PLANNING & ZONING COMMISSION

Regular Meeting Agenda
CITY OF PARKVILLE, MISSOURI

Proposal: Application for Zoning Map Amendment and Application for Preliminary Development Plan for Platte 38, a planned residential development consisting of apartment/condominium buildings and duplexes on 38.24 acres, more or less, generally located to the north of Walnut Creek Acres No 4 subdivision, to the south of The Deuce at The National Golf Club of Kansas City, and to the west of The National 7th subdivision between N Crooked Rd and S National Dr. in Unincorporated Platte County, MO 64152.

**RE: City of Parkville staff review comments – Platte 38 Preliminary Development Plan
(prepared by Renaissance Infrastructure Consulting; dated April 9, 2021)**

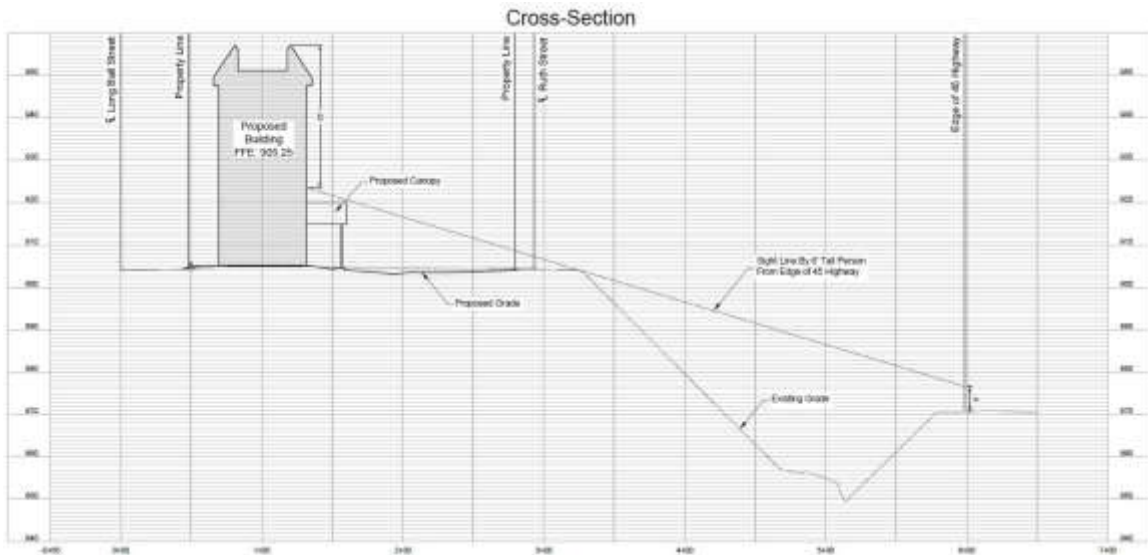
10. **Section View** – Please include a cross-section drawing (or drawings if needed) of the site detailing the height of buildings/structures, distances and relationship to adjacent property parcels, relationship to existing topography, as well as proposed topography following grading/land disturbance. This drawing should include a person or motor vehicle for reference/scale. See image below as an example.

10. Section View – Please include a cross-section drawing (or drawings if needed) of the site detailing the height of buildings/structures, distances and relationship to adjacent property parcels, relationship to existing topography, as well as proposed topography following grading/land disturbance. This drawing should include a person or motor vehicle for reference/scale. See image below as an example.
Site cross-section has been provided. Please see sheet L1.10.
